Town of Parker Community Development Department
Development Review Division
Attention: **Amber Wood-Hicken**

Application Type: **Site Plan**
Status: **First Referral**
Application Name: Canvas F1 L2 - Quick Quack Carwash
Case/AP#: **SP24-86**
Referral Received: August 19, 2024
Comments Due: September 16, 2024

Review date: **August 20, 2024**
Plan reviewer: **Randall L. Capra**, rcapra@parkeronline.org
Phone: 303.805.3163

Narrative: The applicant, Mister Car Wash, is requesting a Site Plan for a tunnel car wash. The site is located on the east side of Parker Road south of Stroh Road.

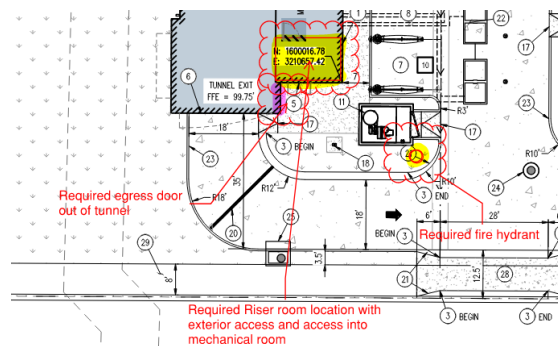
The applicant was notified of the requirement to sprinkle this building during the pre-application process (it is perplexing as to why the sprinkler issue was not addressed); the submittal does not address the required sprinklers or the required fire hydrant. Failure to address the requirements for this site will result in the project being placed into revisions required until all requirements have been met.

9. The code requires that egress, meeting all components of the code, be provided. EM and EXIT signage shall be provided along with an exterior egress door (bay doors are not egress doors and will not be accepted. See the site plan above for an acceptable location for the REQUIRED egress door. Address this issue when resubmitting. *Satisfied with the second submittal; the applicant has noted or acknowledged or addressed at this time.*

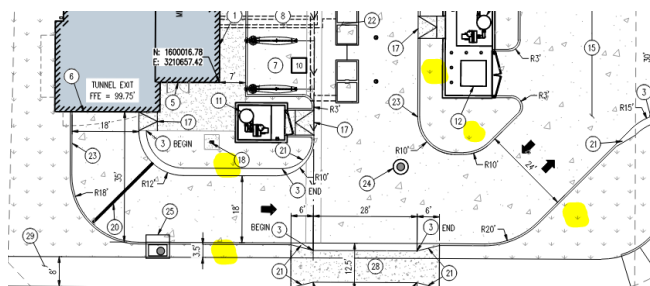
11. The Town of Parker requires that fire apparatus access roads meet the clear-width and weight-bearing standards of the jurisdiction in which the project is located. Roadways shall be designed to support the imposed weight of fire apparatus, 30-ton, two axle and 40-ton three, axle vehicles. An unimpeded clear width of 26-feet shall be always maintained per the requirements of D103.6.1. As such, any location where parked vehicles would obstruct this clear width requirement will require "NO PARKING – FIRE LANE" signage. *This signage shall be red on white. Update design criteria has been provided at the end of this document; ensure compliance when resubmitting. Note – See below for NO PARKING – FIRE LANE signage locations. Satisfied with the second submittal; the applicant has noted or acknowledged or addressed at this time.*

Vehicle Specifications

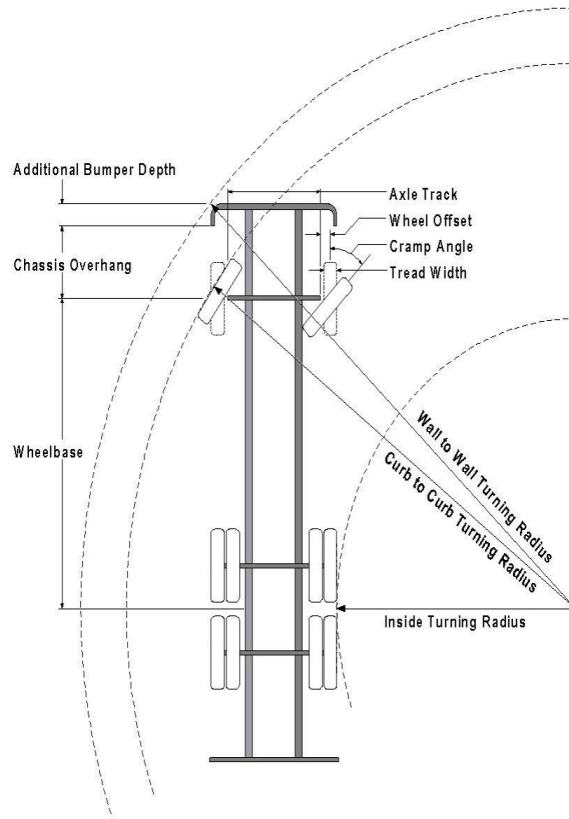
12. The applicant shall provide an auto turn analysis indicating that apparatus can navigate all portions of this site (both sides of the gas canopy); NO PARKING – FIRE LANE signage is required for any portion of the access where the 20-foot clear width requirement cannot be met. This is applicable for the loop around the canopy as well as for each entry. The access on each side of the canopy shall meet his requirement with no portion of the canopy encroaching into the required fire lane access road. See below for the areas required to be included in the auto-turn analysis and address when resubmitting: *Satisfied with the second submittal; the applicant has noted or acknowledged or addressed at this time.*
